Peel Region

DOCUMENT - 2026-353T
INTERIOR RENOVATIONS FOR PEEL REGIONAL POLICE AT 180 DERRY ROAD EAST, MISSISSAUGA
ADDENDUM NO 2

EMIL V. KOLB CENTRE
PEEL REGIONAL POLICE FACILITY
INTERIOR RENOVATION PROJECT
180 DERRY ROAD EAST, MISSISSAUGA, ON L5T 2Y5

1 A003 PARTIAL GROUND FLOOR PLAN-BUILDING CODE SUMMARY
SCALE: 1:100

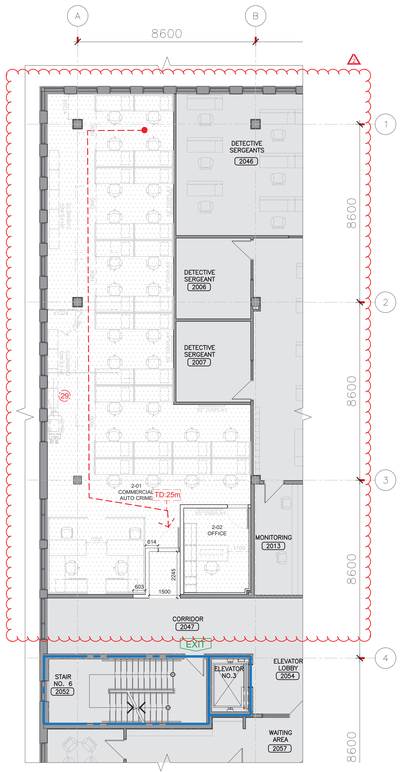
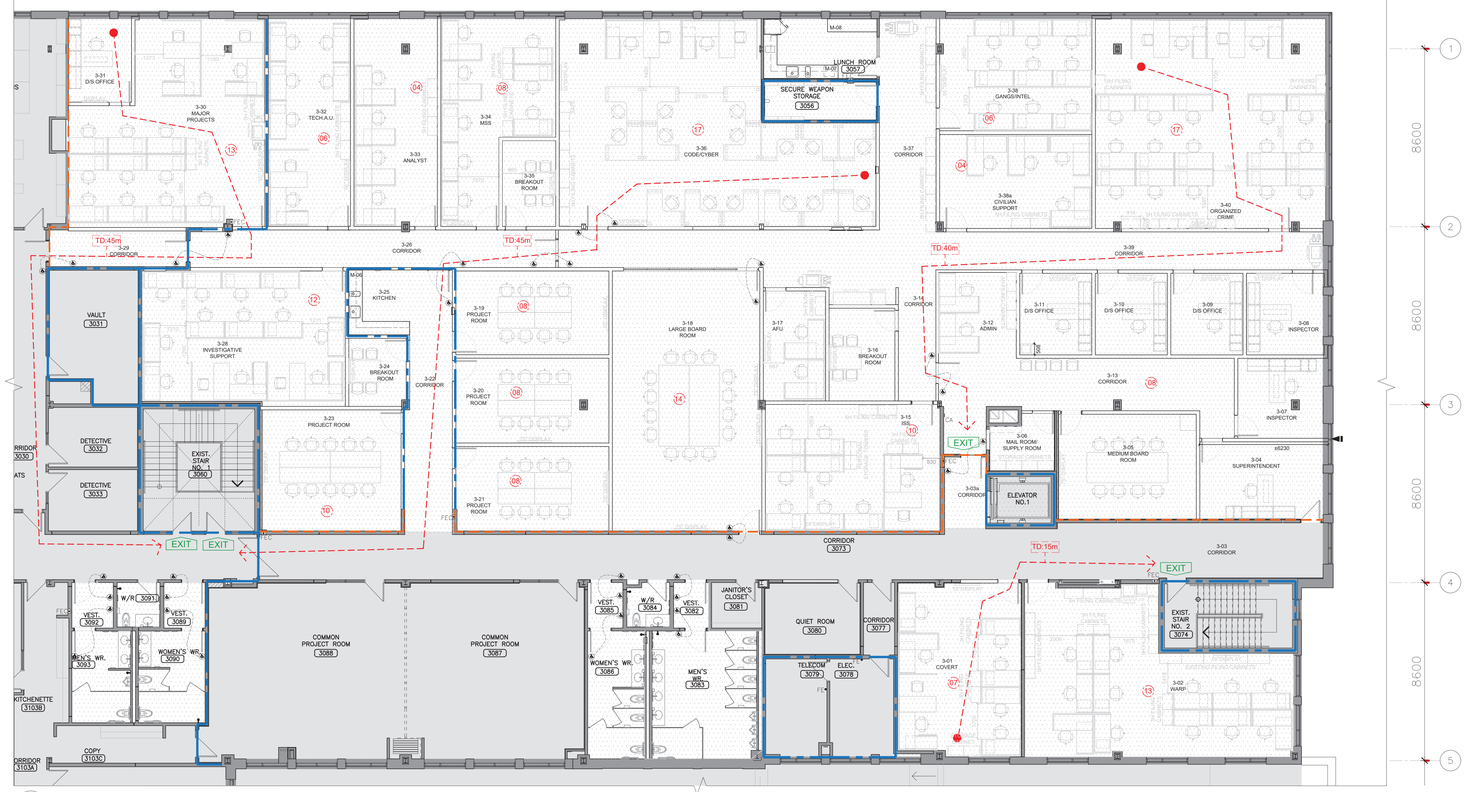
1. Refer to attached drawing A003 for revised Building Code Summary issued for ADD#02 dated June 15th ,2026.

1 A103 REFLECTED CEILING PLAN- DEMOLITION- SECOND FLOOR
SCALE: 1:100

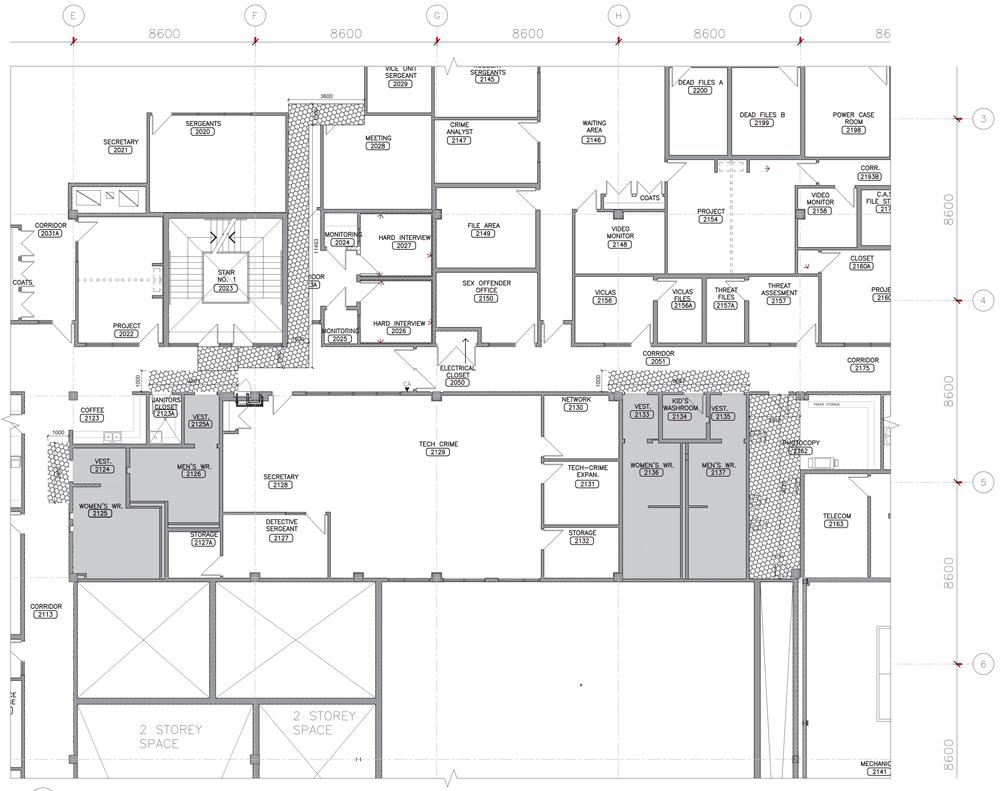
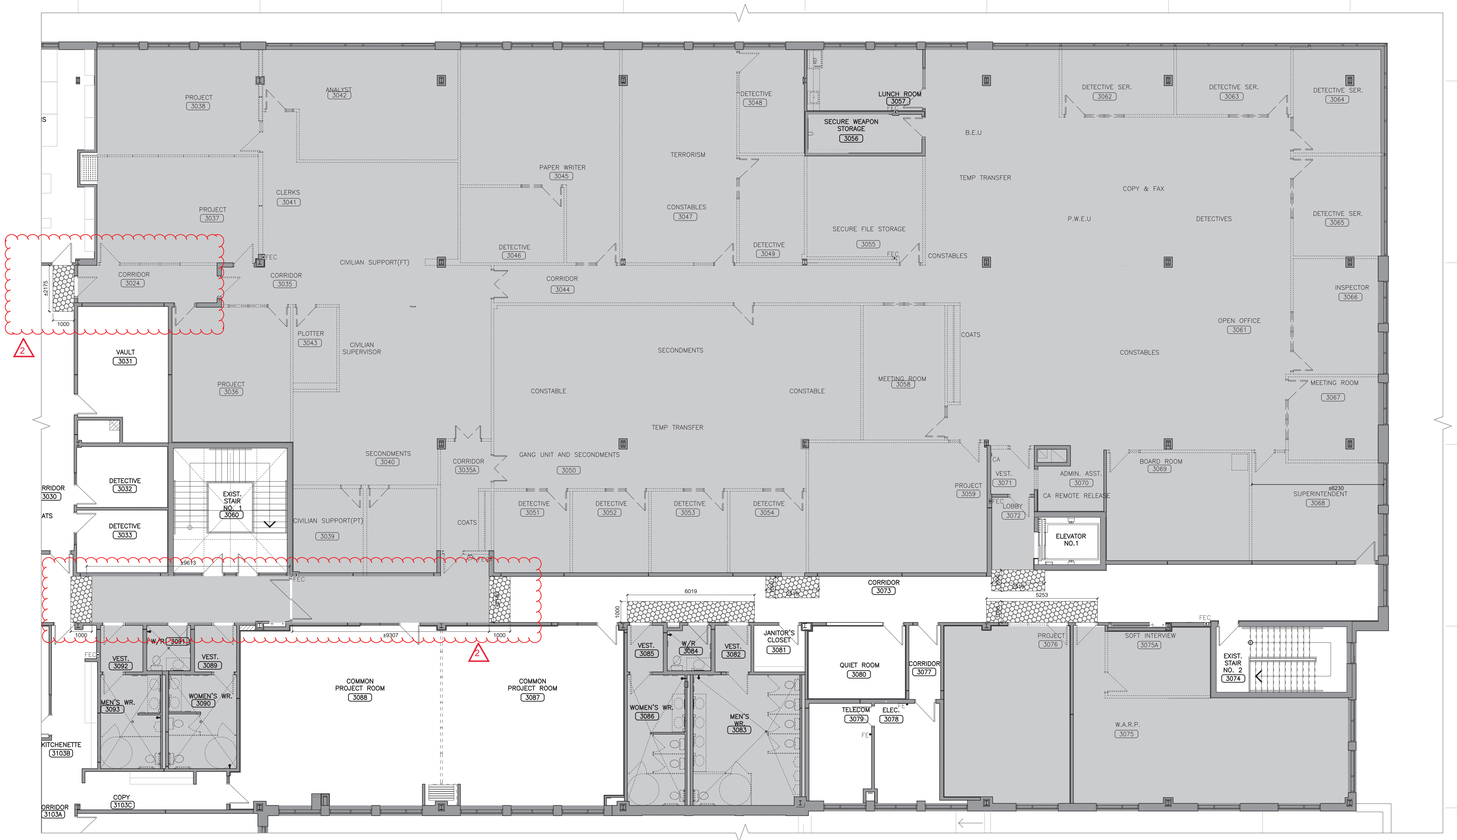
2. Refer to attached drawing A103 for revised reflected ceiling demolition plan issued for ADD#02 dated June 15th,2026.

1 A200 PARTIAL BASEMENT FLOOR PLAN (B0131,B0132,B0138,B0139)-NEW
SCALE: 1:100

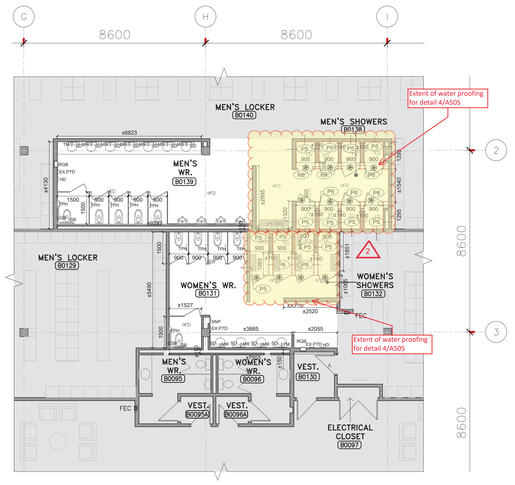
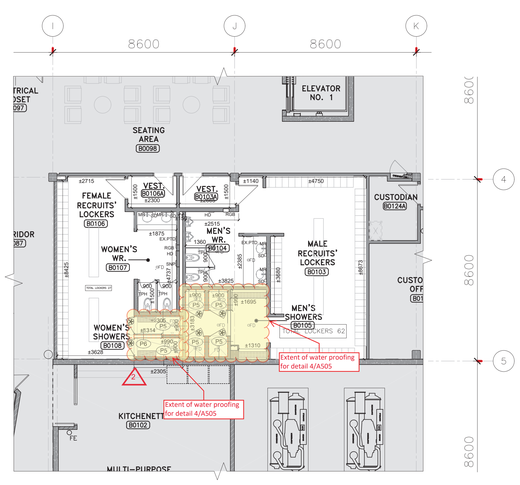
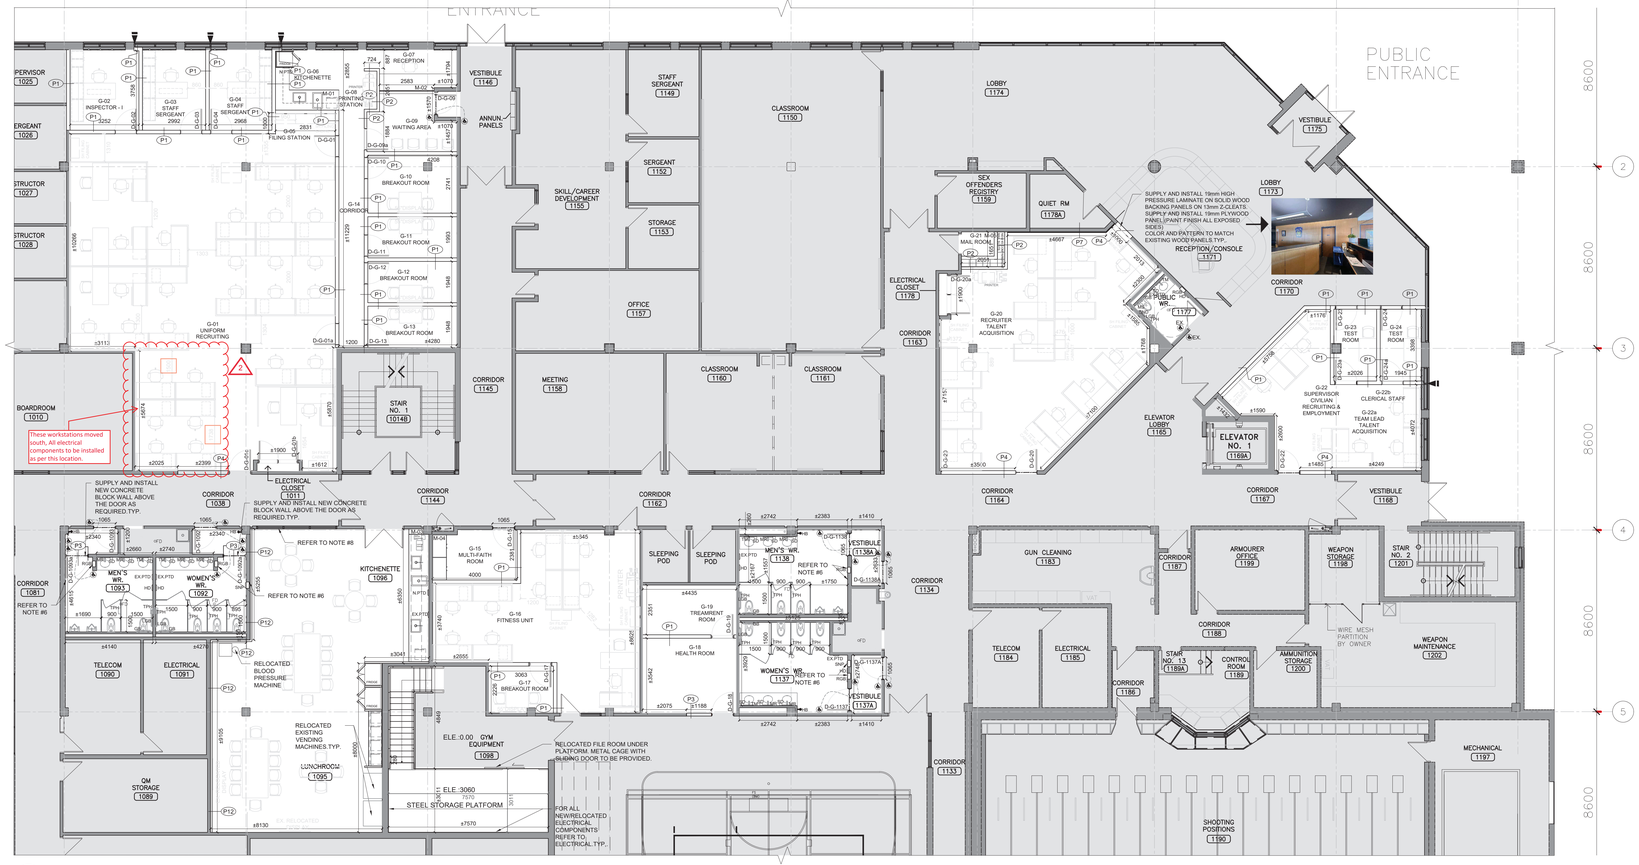
3. Refer to attached drawing A200 for revised floor plan, detail number 4/A200 and floor plan legend issued for ADD#02 dated June 15th, 2026.

1 A201 PARTIAL SECOND FLOOR PLAN-NEW SCALE: 1:100

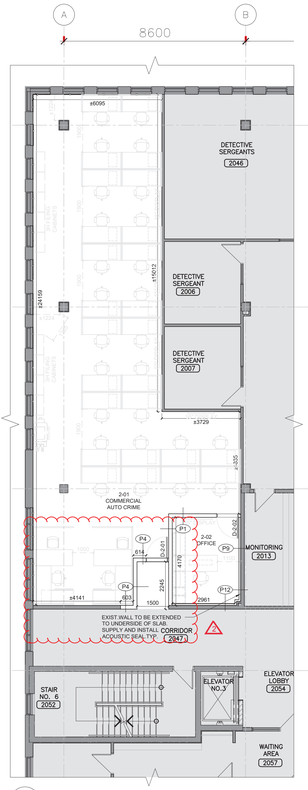
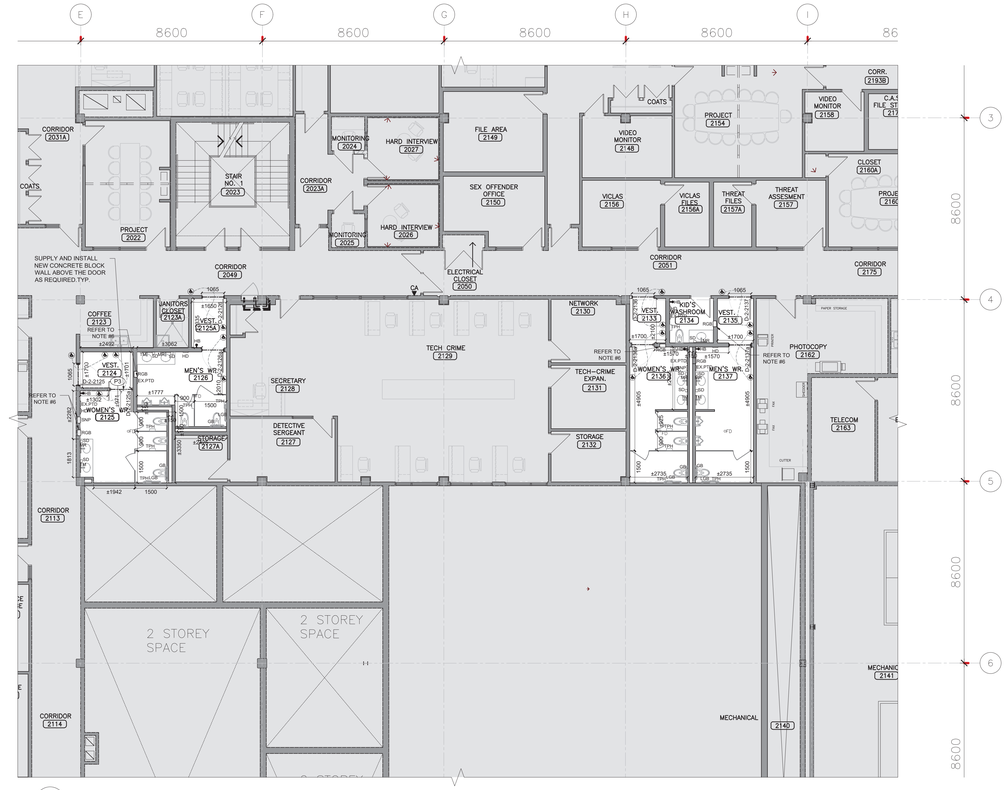
Should the north wall of room 3-18 on A201 actually be labelled P-8 and not P-1?

On drawing A201, what is the extend of the new wall type P8 - Demountable pre-Manufactured Glazed Partition System on the floor plans?

4. Refer to attached drawing A201 for floor plan, revised 2nd floor plan issued for ADD#02 dated June 15th, 2026.

Should include both, P1 & P8. Refer to attached revised floor plan. P1 partition will be above the demountable partition continued to under side of slab to maintain the STC ratings.

Refer to attached revised floor plan

1 A202 PARTIAL GROUND FLOOR PLAN-FURNITURE NEW
SCALE: 1:100

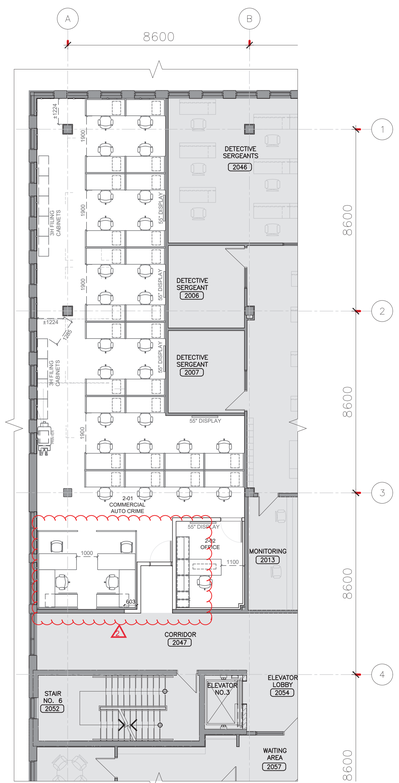
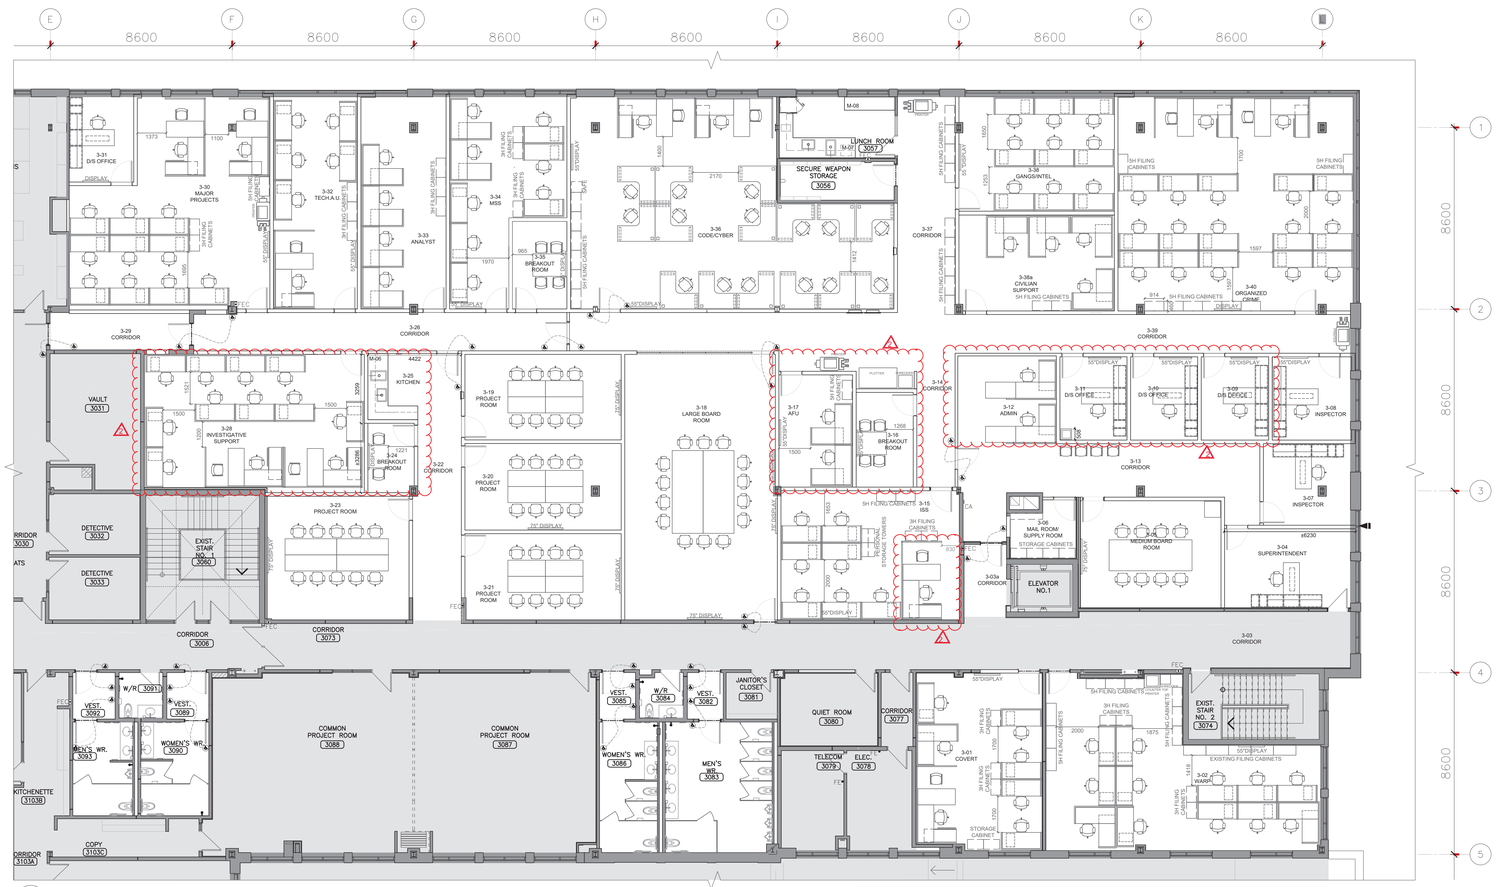
5. Refer to attached drawing A202 for revised furniture plan issued for ADD#02 dated June 15th, 2026.

2 A203 STC RATING PLAN- SECOND FLOOR
SCALE: 1:100

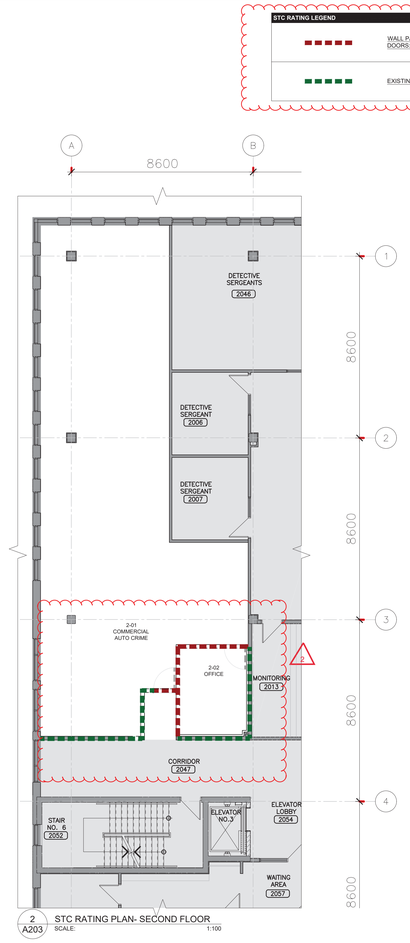
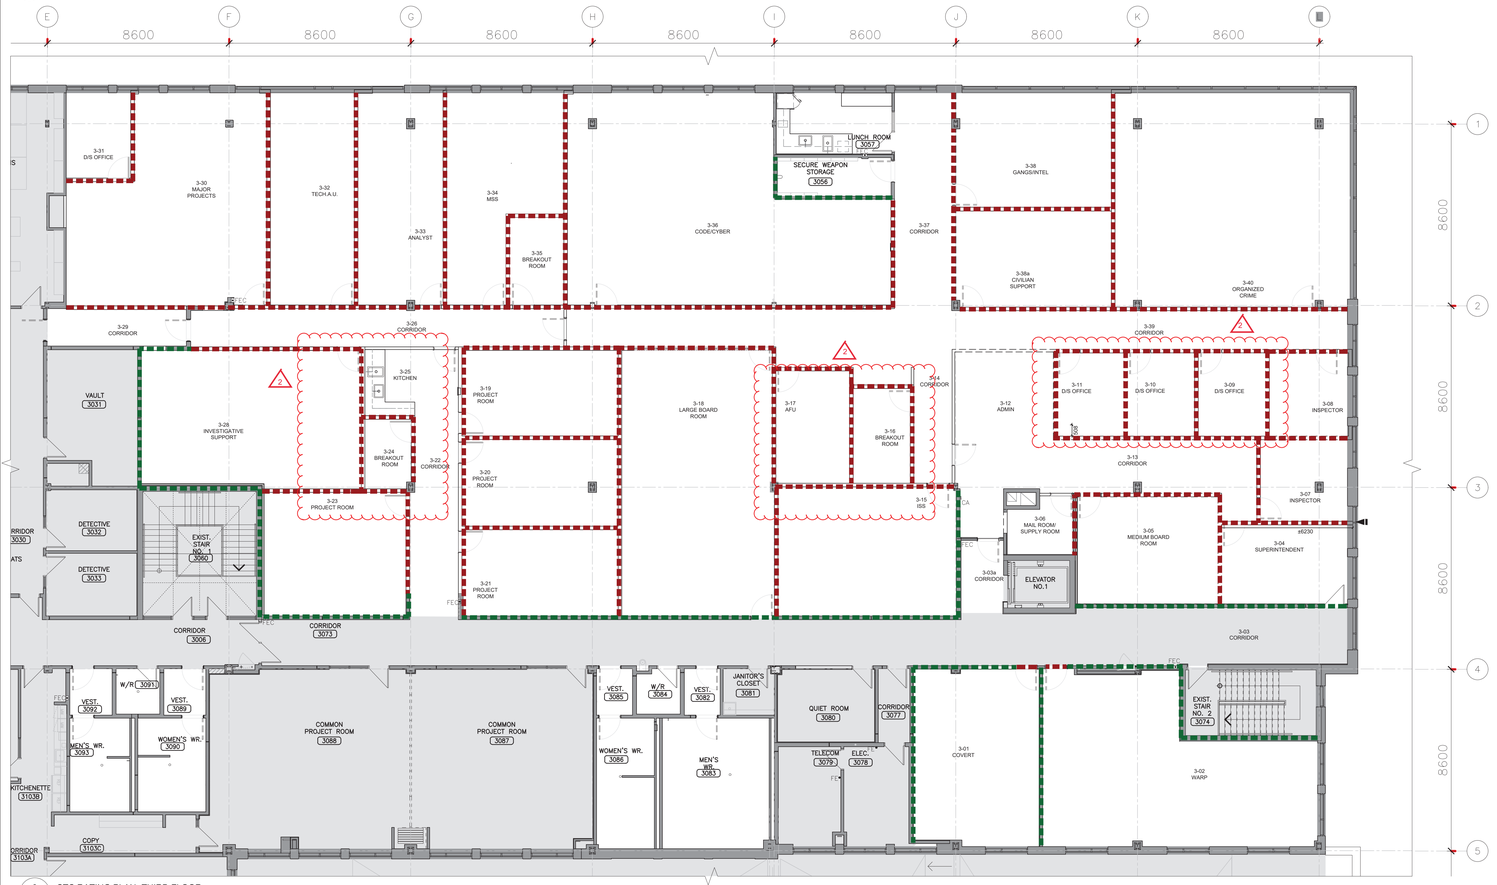
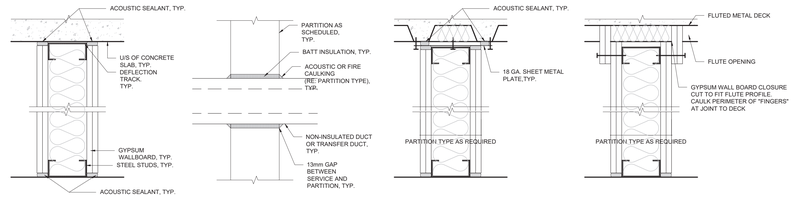
6. Refer to attached drawing A203 for revised STC plan issued for ADD#02 dated June 15, 2026.
